Hurricane Planning Commission Meeting Agenda

September 25, 2025
6:00 PM

Agenda Date:	09/25/2025 - Planning Commission
Application Number:	PP25-14
Type of Application:	Preliminary Plat
Action Type:	Administrative
Applicant:	Western Mortgage and Realty Co
Agent:	Karl Rasmussen
Request:	Preliminary Plat Approval
Location:	East of the intersection of Jellystone Road and 3400 W
Zoning:	R1-15
General Plan Map:	Planned Community
Recommendation:	Table
Report Prepared by:	Fred Resch III

TITLE SHEET FOR:
THE VINEYARDS AT ELIM VALLEY PHASE 1

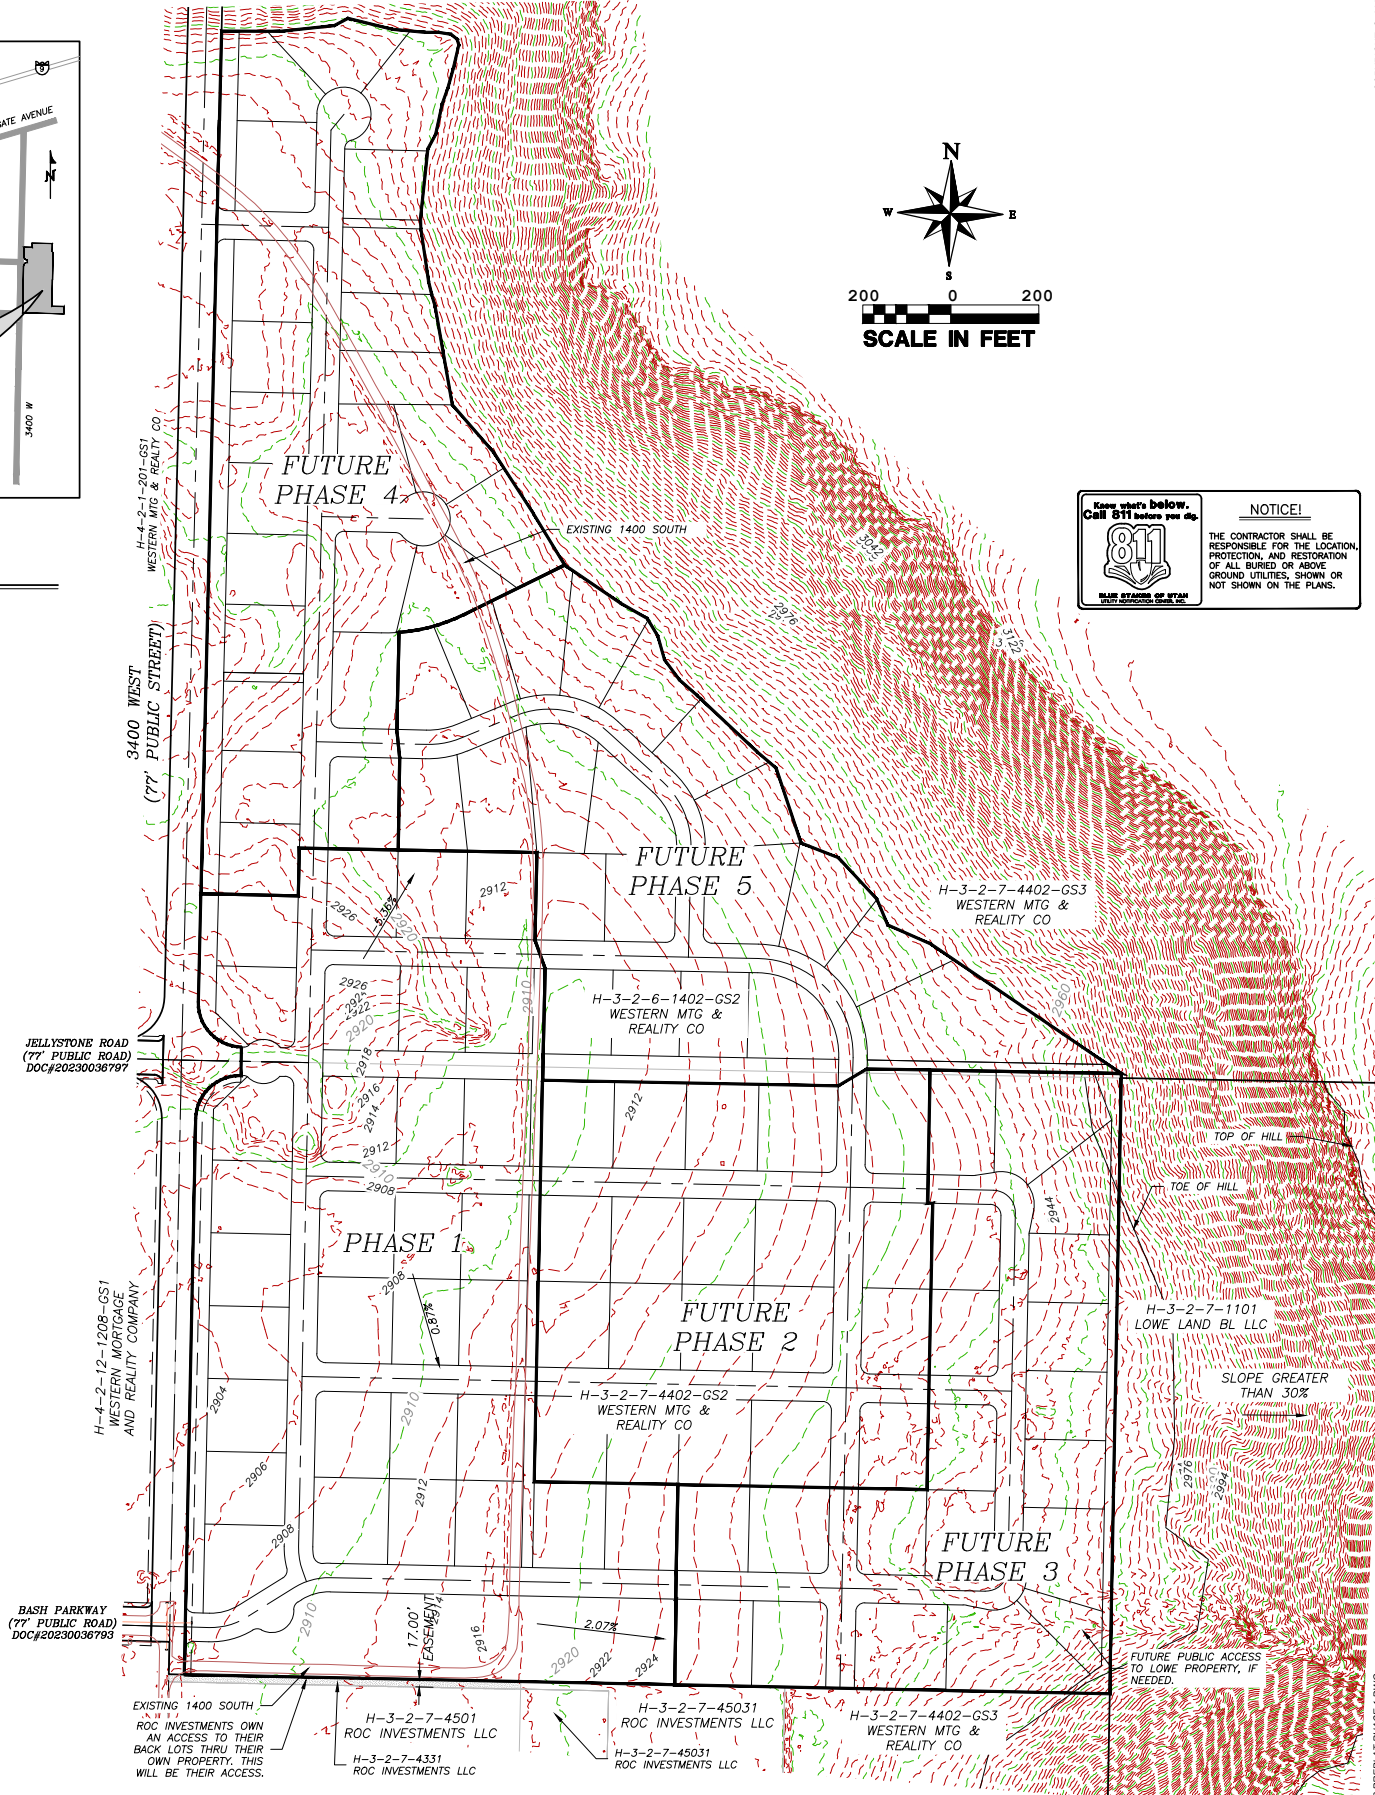
Sheet 1 of 3:

- The area east of future phase 3 is a small area ranging from 100 to 200 feet wide before the toe of the hill leads to slopes greater than 30 percent. However, if access is needed in the future, we are willing to provide it from the south end of future phase 3.

2. If Jellystone Road and 3400 West are excluded for the subdivision boundary they will be treated as a separate project(s), see redlined sheet 3.

- A second water source will be identified and constructed for this development and the note was added to the Existing water and sewer note section.

- 3400 West Road will be built with the development of Vineyards at Elim Valley phase-1. We plan to combine the 2 projects.

EXISTING CONDITIONS FOR:
THE VINEYARDS AT ELIM VALLEY PHASE 1

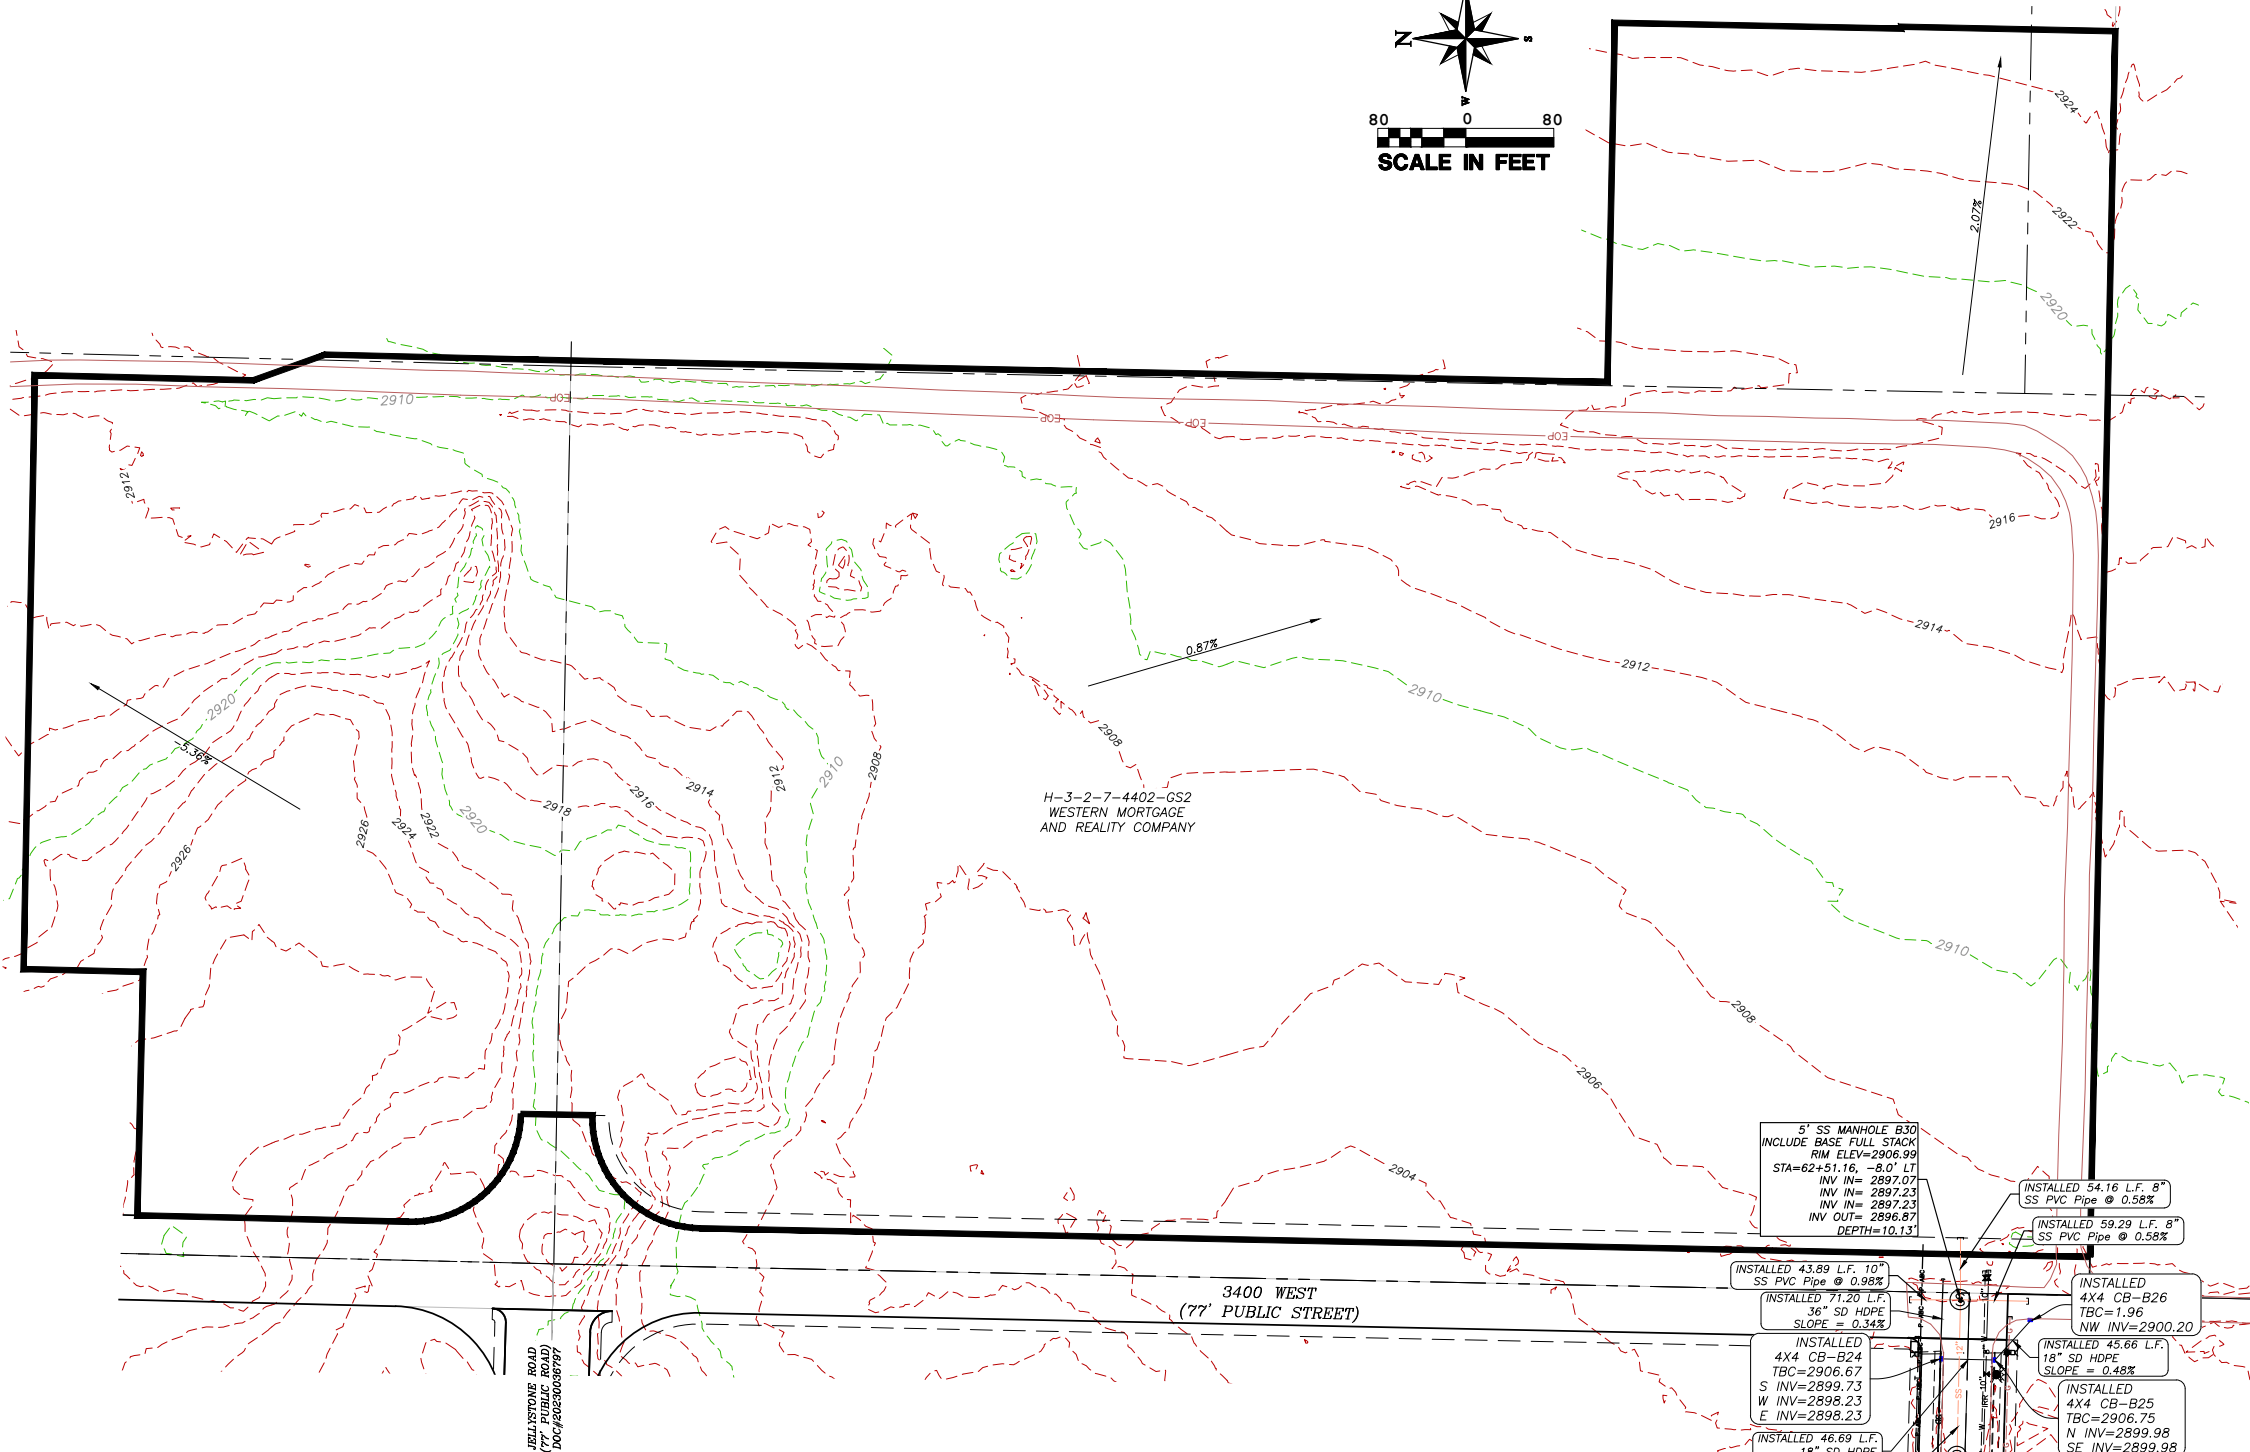
1. It appears the existing Flora tech road must be declared surplus and disposed of by the city council. (HCC 1-10-2) for this project. Existing Flora Tech Road appears to be a public street by use.
 - We will submit the form to dispose of the Flora Tech Road as we build the phases. Right Now, Mrs. Thompson wants Flora Tech to remain accessible as long as possible. We can make this change during the final plat process of Phase 1.

PRELIMINARY PLAT FOR: THE VINEYARDS AT ELIM VALLEY PHASE 1

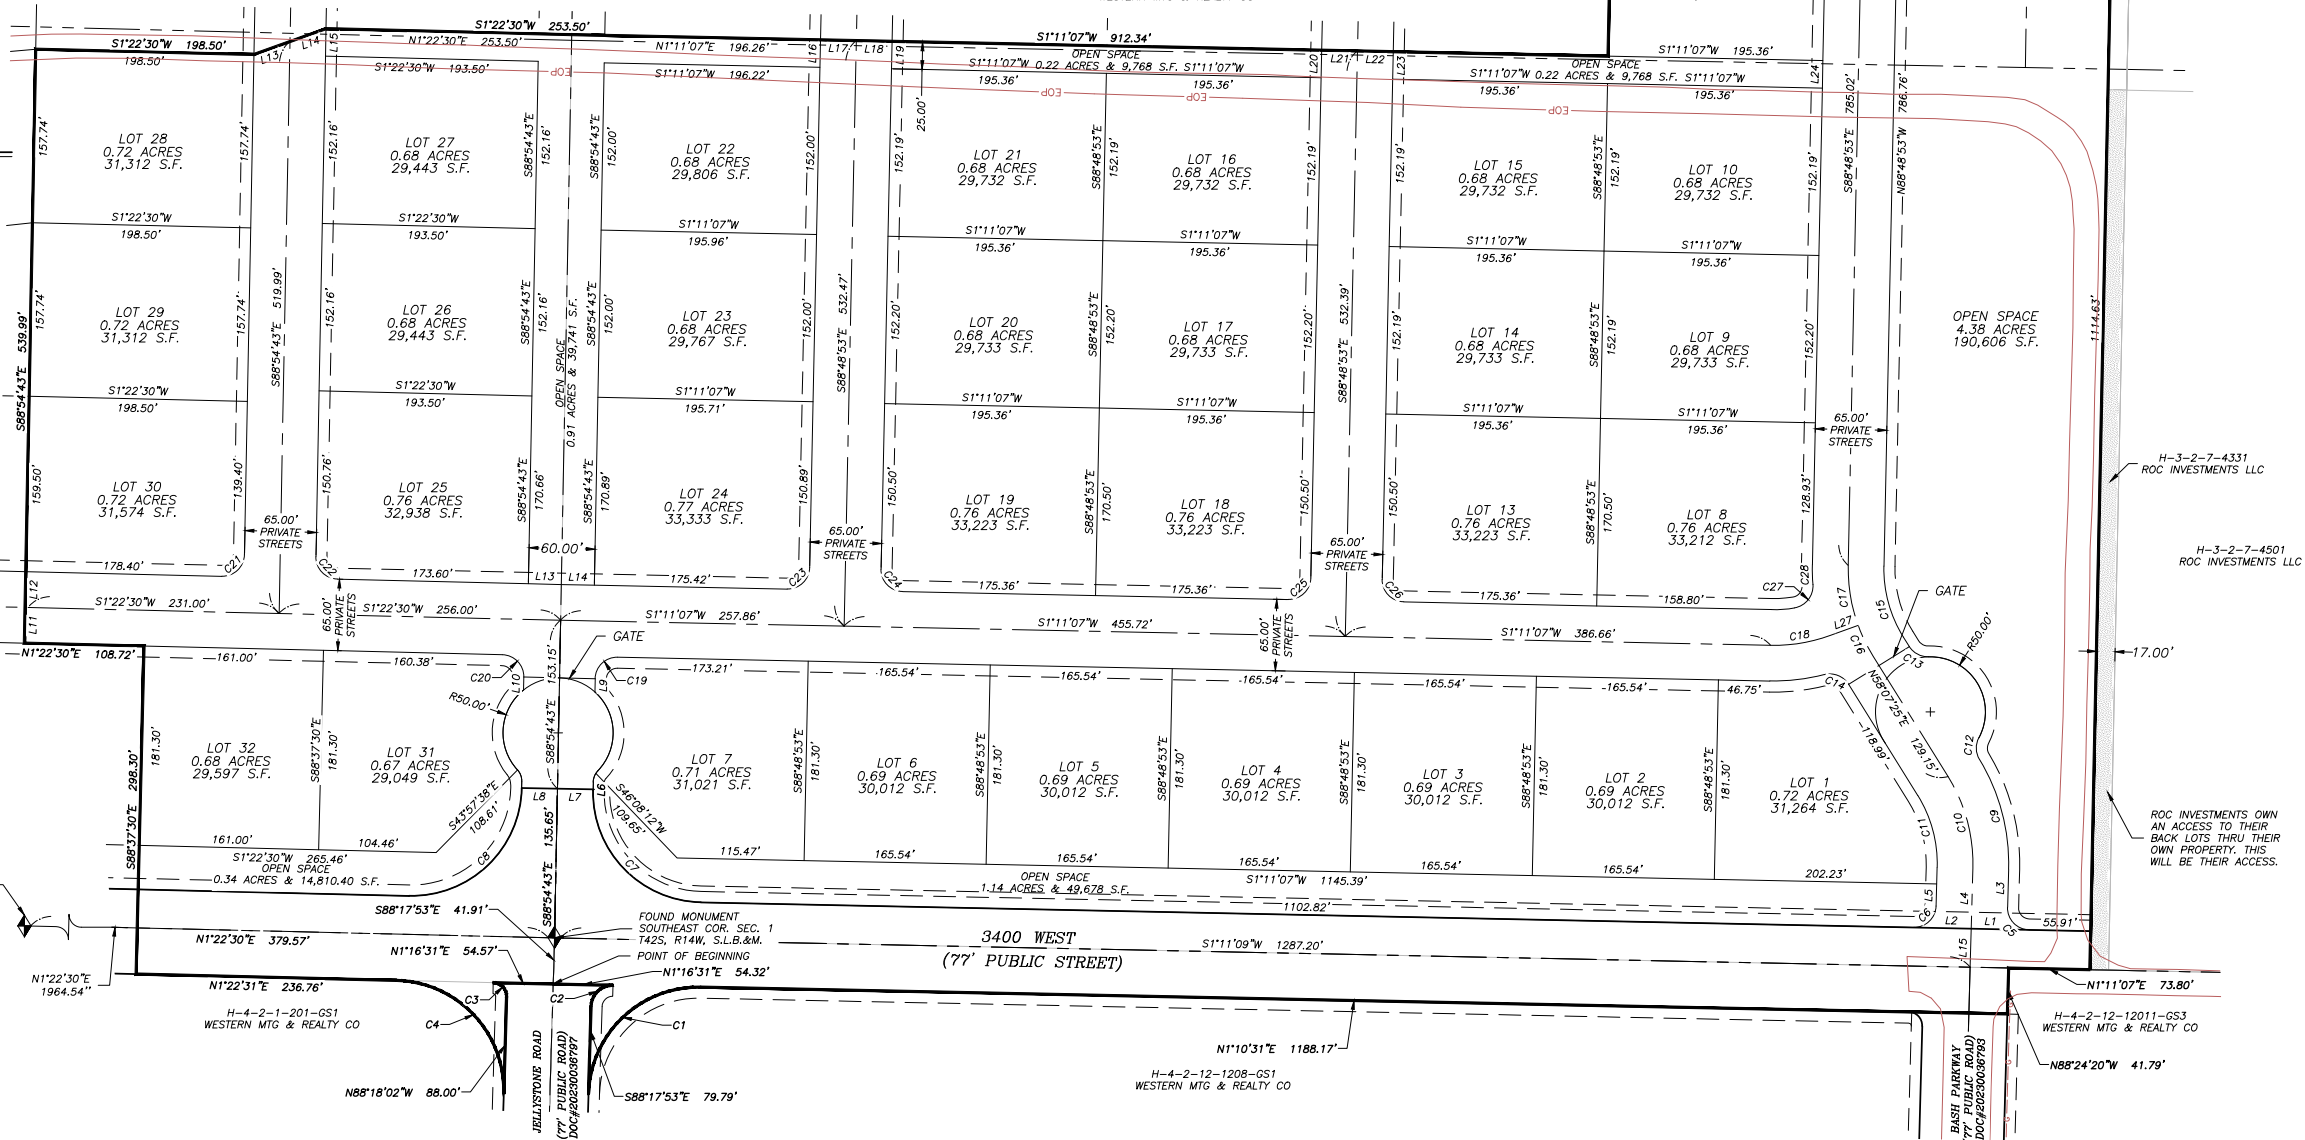
1. **Offsite construction plans for Jellystone Road must be reviewed and approved (HCC 10-39-6)).**
 - Jellystone Road plans are approved up to the intersection of 3400 West. This is being built and any grade changes will be submitted to the engineering department for review.

4. **Fix ROW width on 65' Typical Road cross section.**
 - ROW width on 65' is fixed to 30'
5. **Construction plans for Flora Tech Road (3400 Wes) have yet to be reviewed and approved for construction (HCC 10-37-4). It seems that including the segment of Flora Tech Road that this development "front" as a part of this preliminary plat will show that the developer will provide adequate public facilities for themselves.**

- This is correct. 3400 West Road will be built with the development of Vineyards at Elim Valley phase-1.
6. **My office needs documented justification to vary from the standard 800' maximum block length mentioned in HCS 3.4.2.2(F) for neighborhood roadways. Especially when an existing driveway for the property to the south would be disrupted by this proposal.**

- We had meetings with staff on the typical cross section we would like to install. We will first seek City Council approval after the planning commission approval.

- We prefer not to construct a road between Lots 3 and 4 and instead propose using a 25-foot right-of-way with a 12 foot trail to provide access between the lots. Building roads every 3 to 4 lots takes away from the theme we want for the Vineyards.
